URGENT MEDICAL DEVICE SAFETY INFORMATION AND CORRECTION

Defibtech DBP-2800 Battery Packs

May 20, 2010

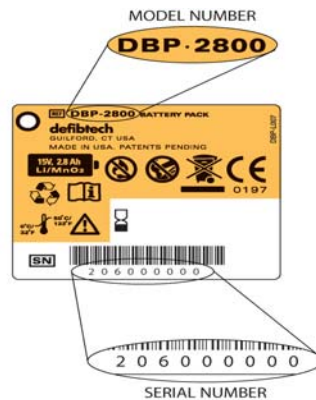
- 1) Remove the battery pack from the DDU-100 AED and inspect the battery pack label. As illustrated below, your battery pack label identifies the model or type of battery pack.
 - If your battery pack model number is DBP-2800, please go to step #2.
 - If your battery pack model number is NOT DBP-2800 (e.g. DBP-1400, DBP-RC2), your battery pack is not affected by this recall. Please go to step #5.

- 2) **Only DBP-2800 battery packs shipped prior to June 4, 2007 are affected.** To determine if your DBP-2800 battery pack is affected:
 - Find the 9-digit serial number on the battery pack label as illustrated below.
 - Affected battery pack serial numbers range:
 - a) Between 202001005 and 202005916, or,
 - b) Between 206001001 and 206009871.
